Access Compliance Report

Public Rights-of-Way

(Curb Ramps)

Intersection ID: 14648		Main Street: EAST_BV		Cross Street: LENNOX_AV		Location: NE			
ADA ID: B3F1DA88A0FB		Ramp Type: Perp		Initial Pass/Fail: Pass		Overall Compliance: No		Severity Score: 15	
Codes/Mitigation Info/Possible Solution					Field Measurements/Component Compliance

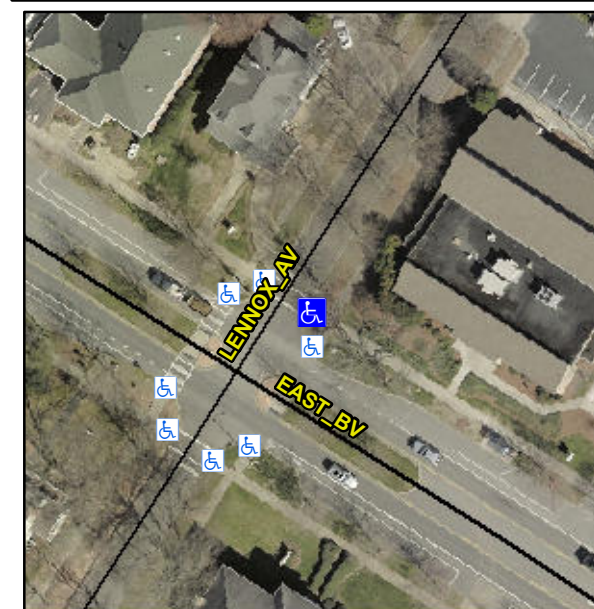
Not Found, R304.2.1, R305.2, R302.7.2

Compliance	Description	Data	Compliance	Description	Data
N/A	Ramp Length (in)	74.0	Yes	Ramp Slope (%)	5.9
Yes	Ramp Width (in)	72.0	Yes	Ramp XSlope (%)	0.3
Yes	Flare Type L	Curbed_NoWalkSurface	Yes	Flare Type RT	N/A
Yes	Flare Slope LT (%)	N/A	N/A	Flare Slope RT (%)	N/A
N/A	Flare Traversable LT?	No	N/A	Flare Traversable RT?	No
No	Landing Length (in)	45.0	Yes	DWS Provided?	Yes
Yes	Landing Width (in)	72.0	Yes	DWS Contrast?	Yes
Yes	Landing Slope (%)	0.7	Yes	DWS Length (in)	24.0
Yes	Landing X Slope (%)	0.7	Yes	DWS Full Width?	Yes
N/A	Landing Curb? (Y/N)	No	No	DWS Offset (in)	3.0
N/A	Shared Landing?	No			
Yes	Gutter Ponding?	No	Yes	Gutter Slope (%)	3.9
No	Gutter Lip Ht (in)	4.0	Yes	Gutter X Slope (%)	0.6
N/A	Painted X Walk1?	No	N/A	Painted X Walk2?	N/A
	X Walk 1 Direction	To NW		X Walk 2 Direction	N/A
N/A	X Walk 1 Width (in)	N/A	N/A	X Walk 2 Width (in)	N/A
	X Walk 1 Slope (%)	6.1		X Walk 2 Slope (%)	N/A
	X Walk 1 X Slope (%)	0.4		X Walk 2 X Slope (%)	N/A

N/A	Ramp inside XWalk1?	N/A	N/A	Ramp inside XWalk2?	N/A
	Road Slope (%)	N/A	N/A	Clear Space?	Yes
	Road X Slope (%)	N/A	N/A	Clear Space to XWalk (in)	N/A
Yes	Any Obstructions?	No	Yes	Storm Grate/Utility Hazard?	No
	Obstruction Type			Storm Grate/Utility Type	
		N/A			N/A
			Yes	Surface Condition? (G/P)	Good

Remove & Replace Entire Ramp.
